# DESIGN REVIEW BOARD RECOMMENDATION MTG

## TROY LAUNDRY / BOREN INVESTMENT BLOCK

DPD PROJECT #3012675  
06.26.2013

# ENTRY AT NORTHEAST CORNER

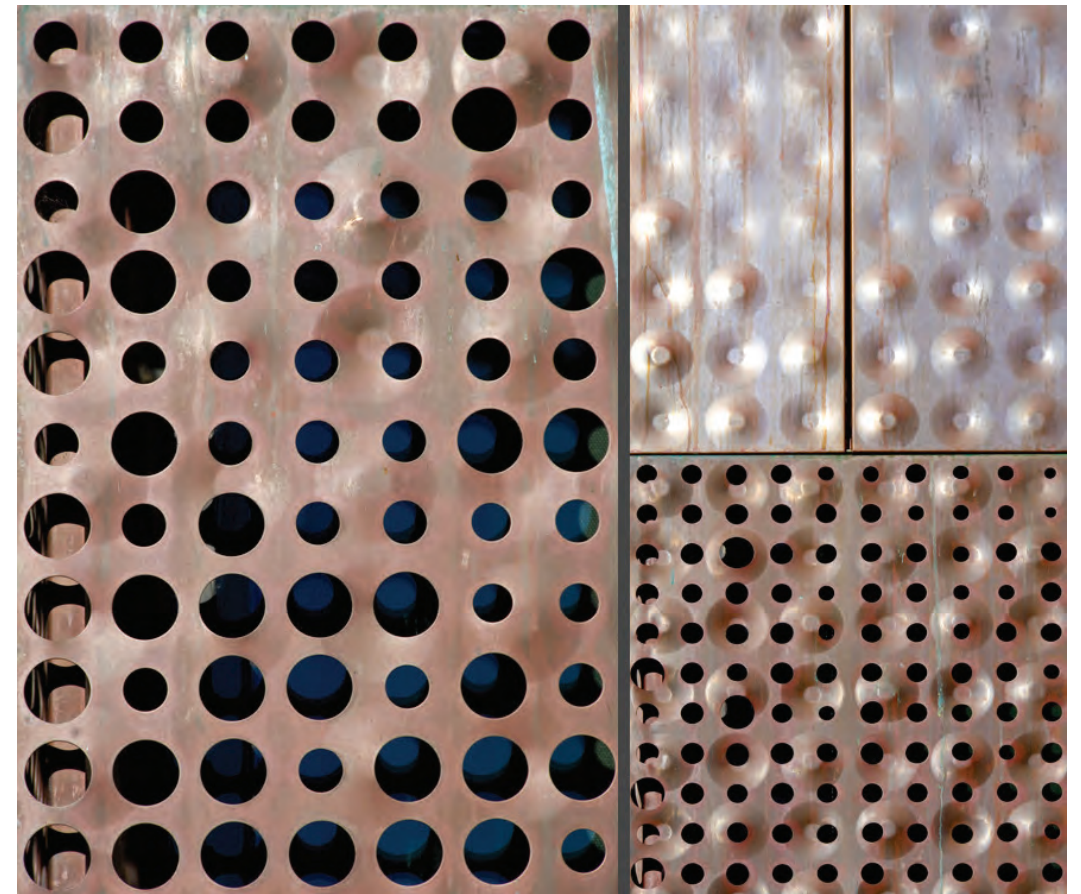
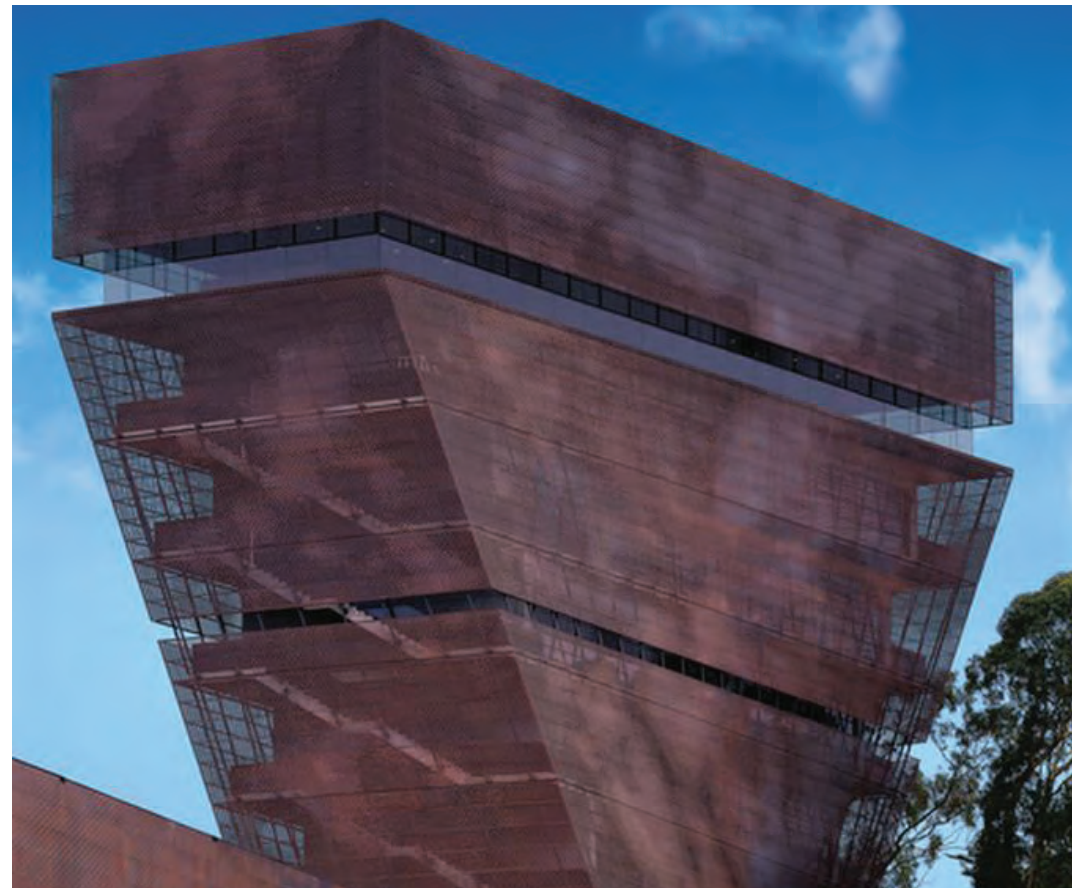
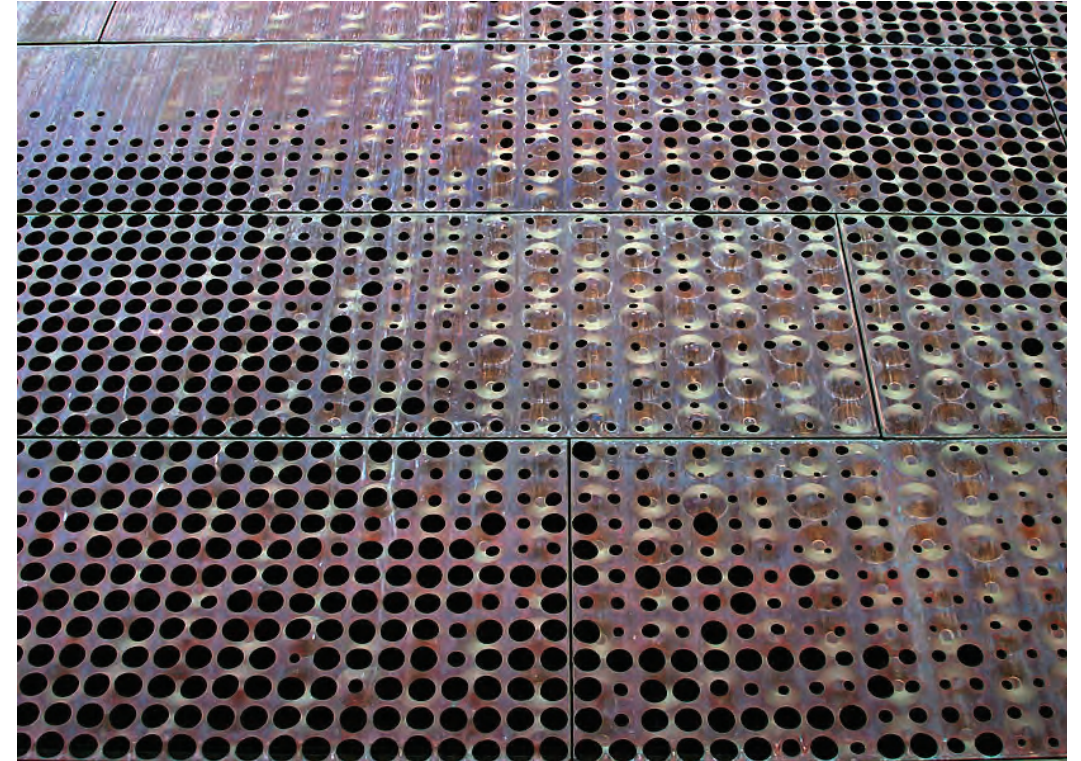
b. The Board indicated support for the departure for transparency and blank walls to allow the use of perforated metal panels at entries, provided that the perforated panels are designed to **create visual interest and human scale**. The applicant should demonstrate creative use of the perforated metal panels, as well as possible benches and landscaping to soften the use of this panel and create human scale and visual interest at the entries. (A-3, C-2, C-3, D-1, E-2)

c. The Board appreciated the articulation indicating the entries at the northeast and southwest corners. However, the Board directed the applicant to further develop the articulation to both **enhance the entries** and **reduce the scale** of the north, east, and south facades. (A-2, A-3, B-1, C-2, D-1)

We have increased the vertical slot that identified the two entrances to be a glass box element that holds the corner and protrudes outward from the “jacket” to the north and south respectively. The box is held down from the top of the building for modulation and scale reduction.

The perforated stainless panels at the entries have been identified as locations for art. We are in the process of identifying an artist to use these perforated panels as a canvas. We are in contract discussions with Cath Brummer at 4 Culture to help identify and Northwest artist. On the follow pages we have show examples of what we envision how the perforated stainless pattern to will look and feel.

# DEPARTURE #10

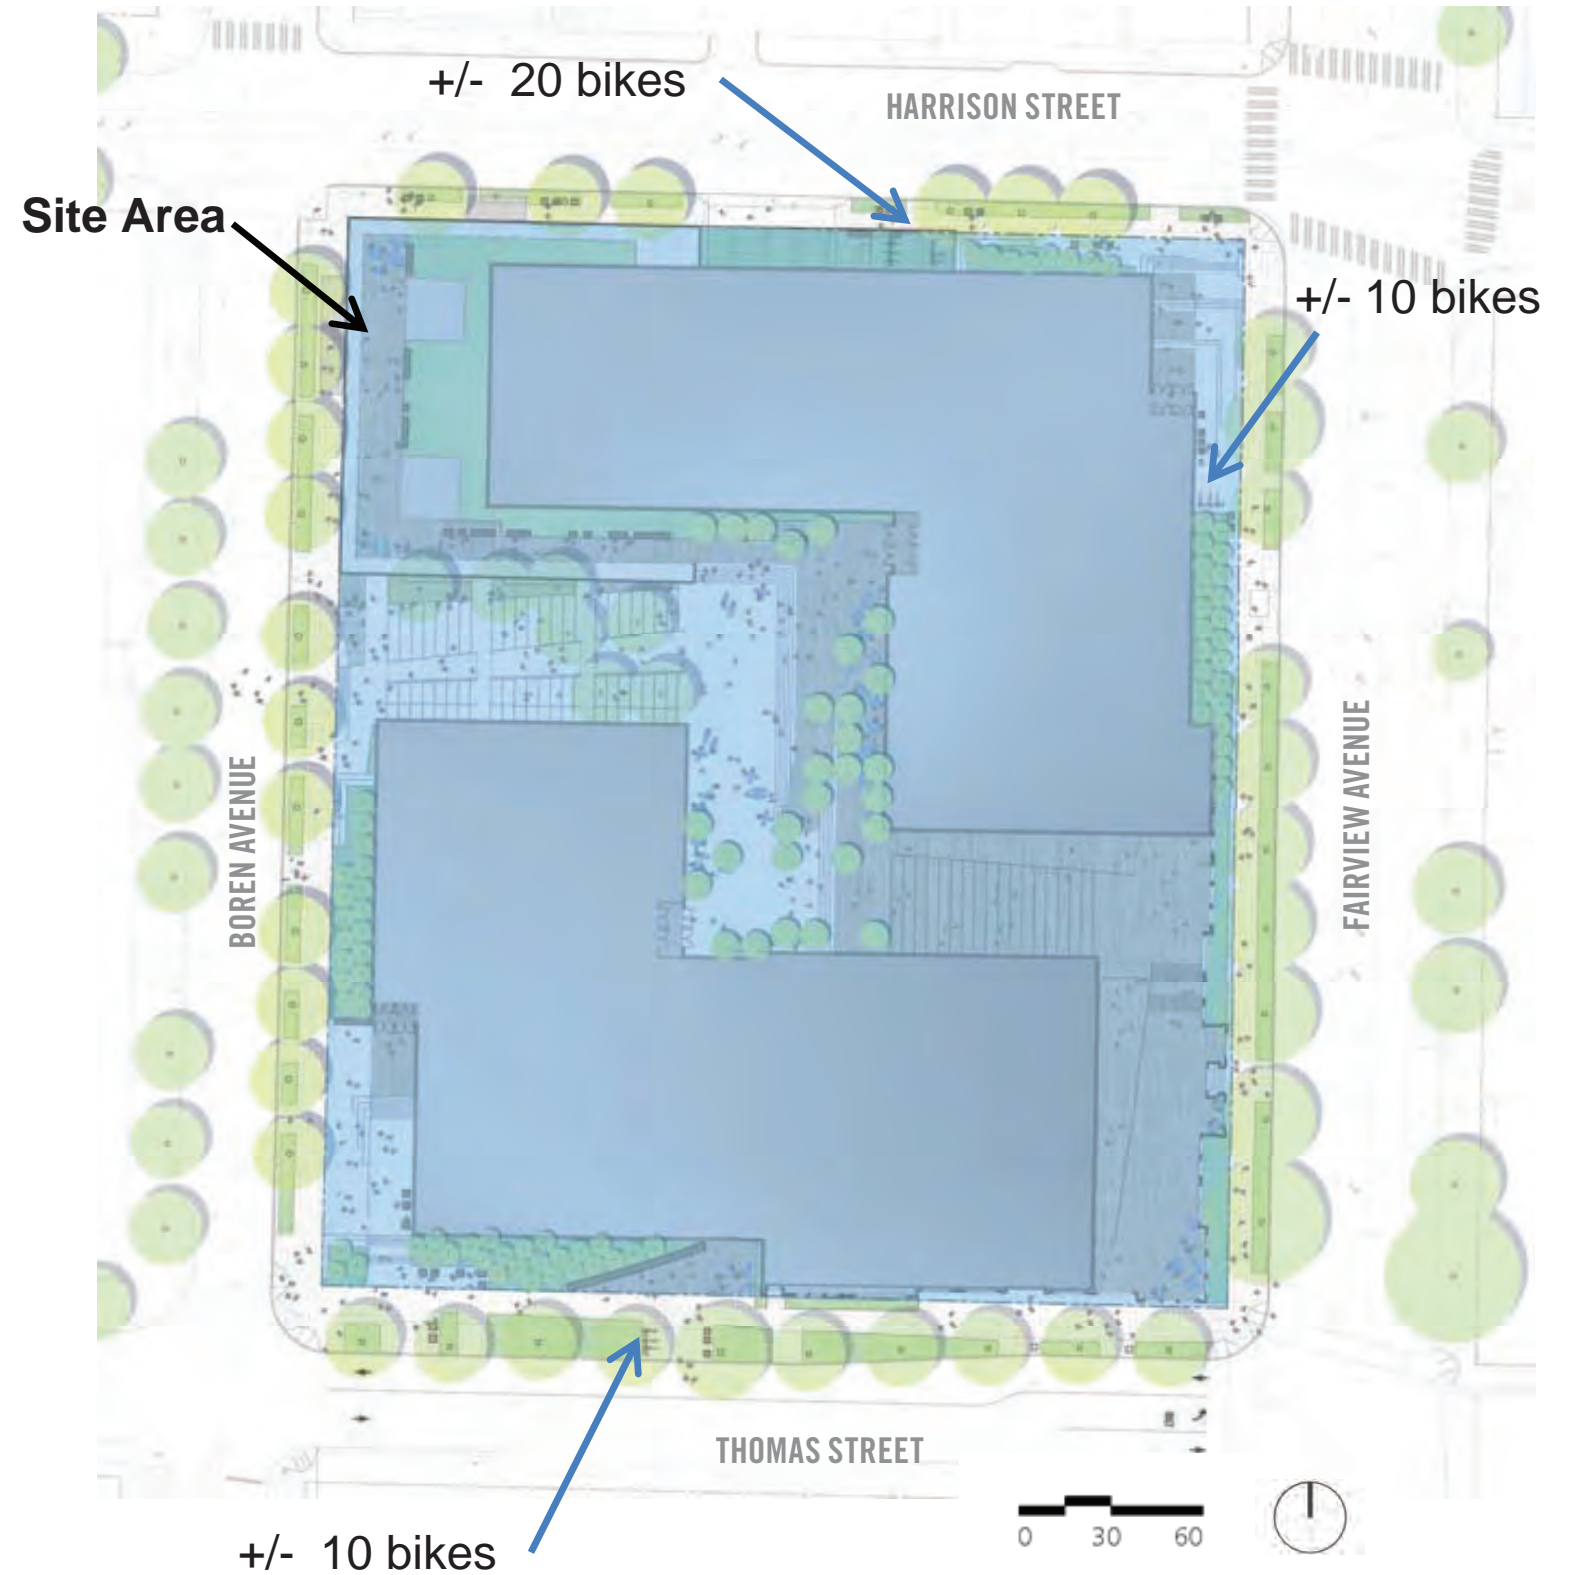
SMC 23.48.013F4c requires landscaped open space an amount equal to 15% of the lot area (or 16,369.35 sq ft) at ground level.

SMC23.48.013F4g requires the project to address the needs of pedestrians and provide bike facilities. Consideration of these requirements will be made in consultation with Shelley Bolser based on needs that may be identified through the Design Review process.

- The proposal provides active, public open space geared towards maximum usability and mid-block pedestrian access and circulation.
- The proposal offsets the percentage of hardscape with dense plantings of columnar trees, green roofs and vine covered walls and trellises.
- The proposal provides pedestrian furnishings supporting gathering and public use that does not interfere with pedestrian traffic flow.
- Preliminary study shows feasible solutions to increase percentage of landscaped area to 10%.

- Total parking for approx 40 bikes with 20 under trellis cover.
- Additional bike parking is feasible.

# DEPARTURE #11

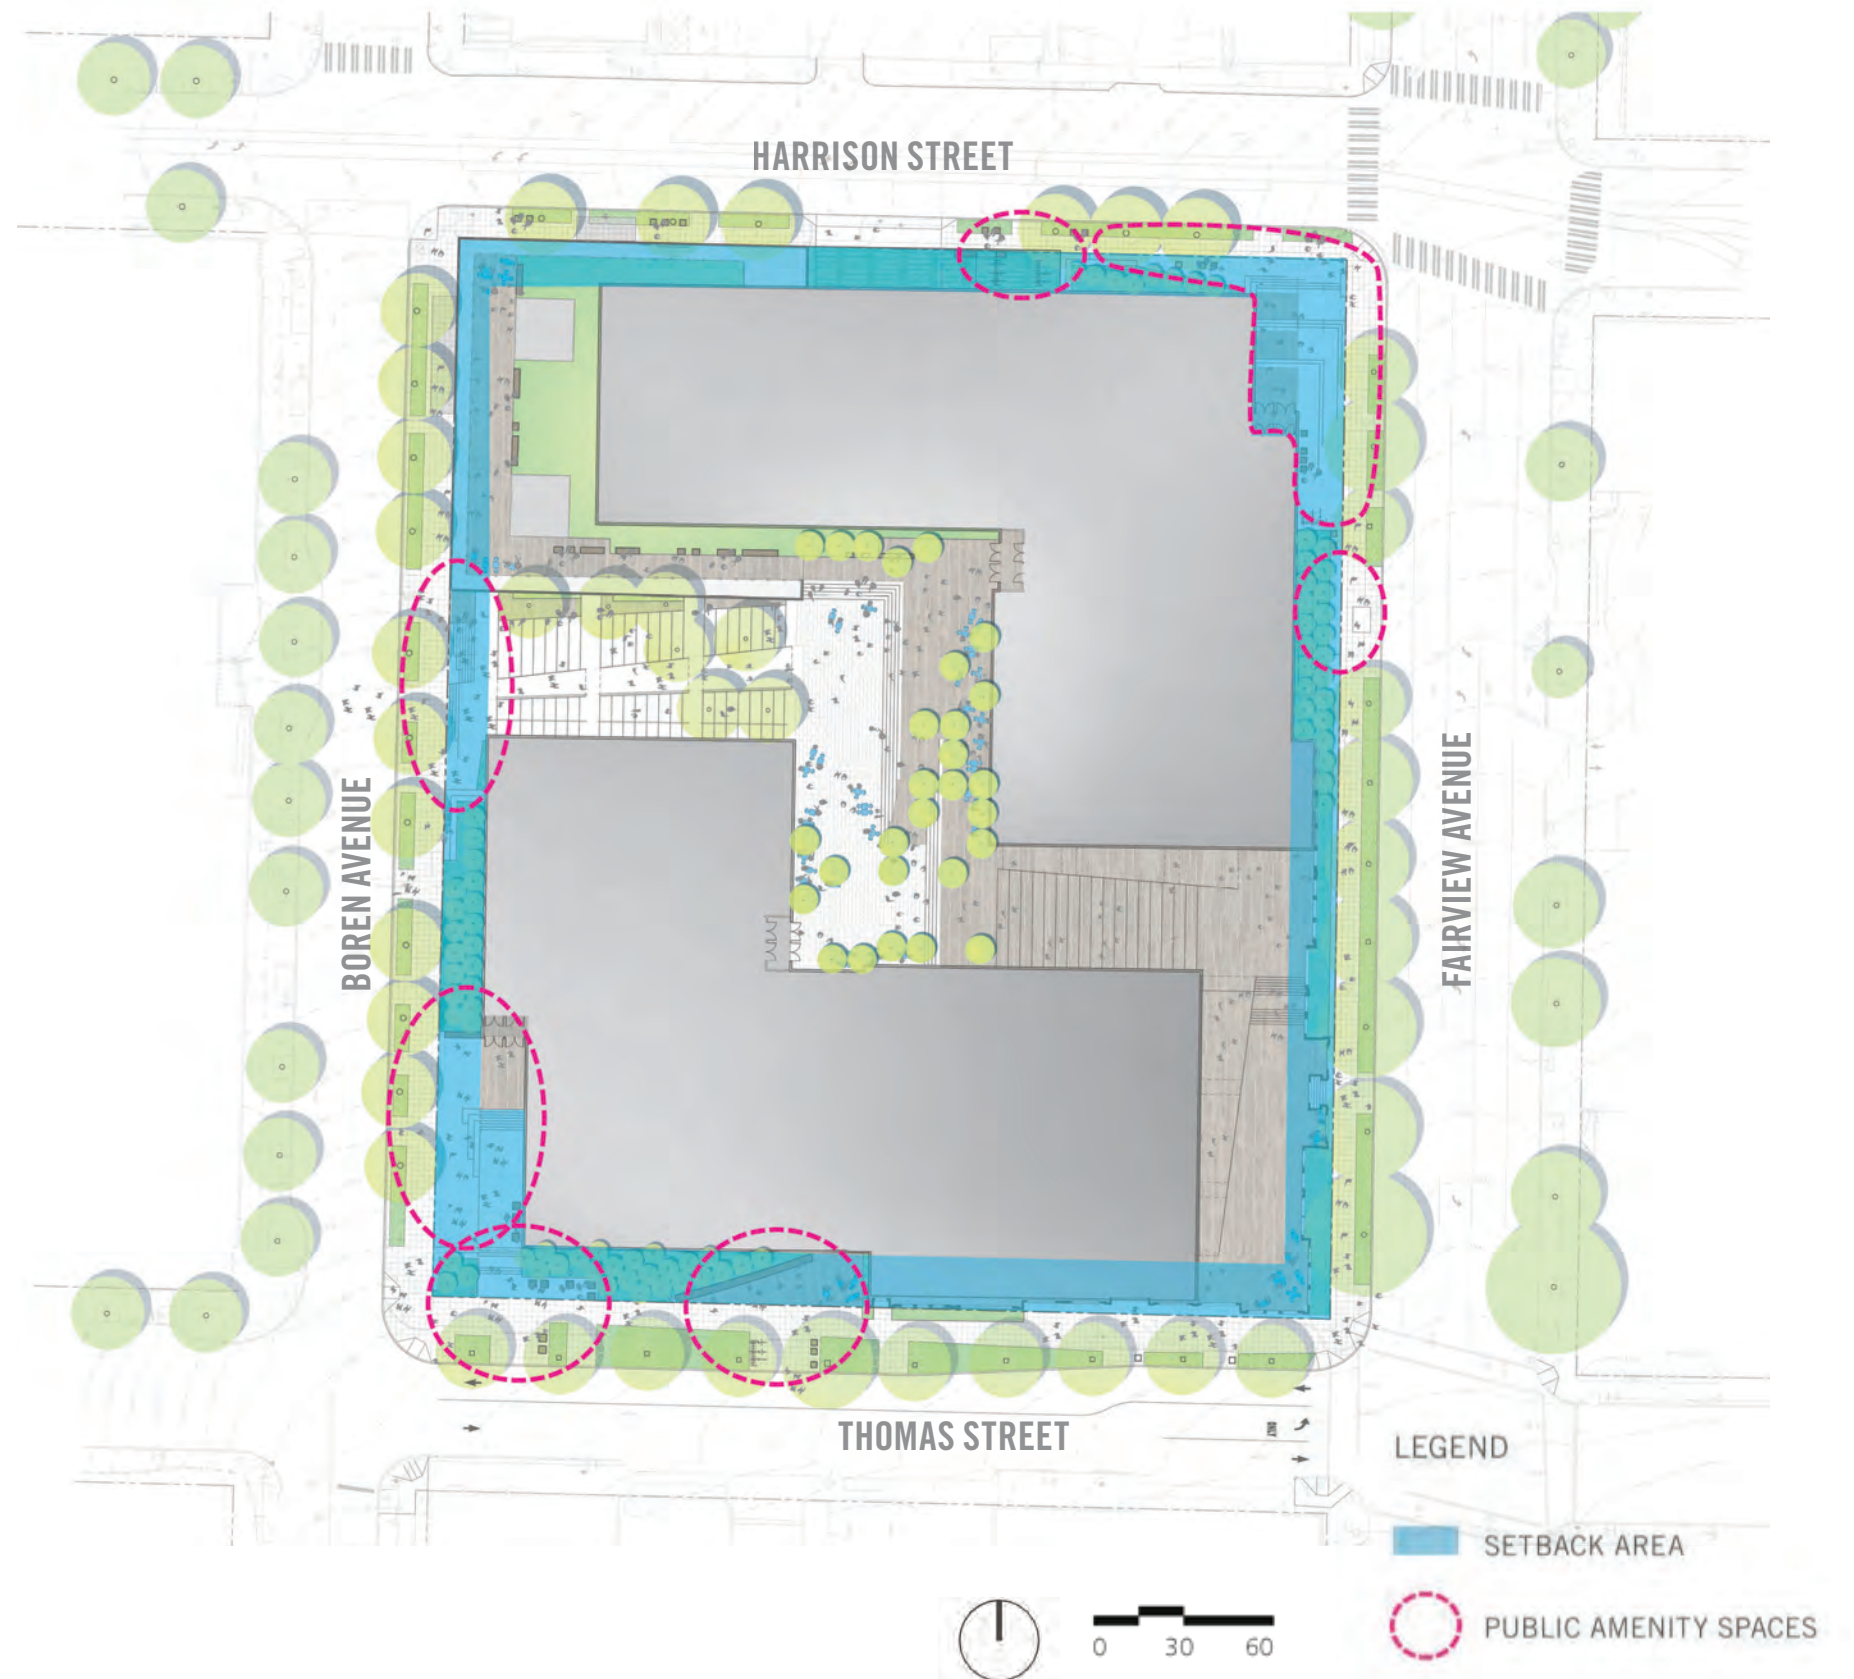
Landscaping for Setback Areas and Berms. Each setback area or berm required shall be planted with trees, shrubs, and grass or evergreen groundcover. Features such as **pedestrian access** meeting the Washington State Rules and Regulations for Barrier-Free Design, decorative pavers, sculptures or fountains may cover a maximum of **thirty (30) percent** of each required landscaped area or berm.

- The proposal offsets the percentage of hardscape with dense tree plantings, green roofs and vine covered walls and trellises w/in the setback in conjunction with publicly accessible plaza spaces with seating, lighting and surrounding landscape in an effort to provide a maximum of public amenity spaces and signal desired public use.
- The proposal meets Green Factor requirements and supports Green Streets objectives, in part, through the use of extensive ROW plantings and GSI plantings on Thomas Street.
- The historic Troy and Boren buildings have green roofs.
- In support of Harrison Street Heart Location objectives, an extensive vine covered trellis spans the vehicular entry to the underground parking and the bike parking.
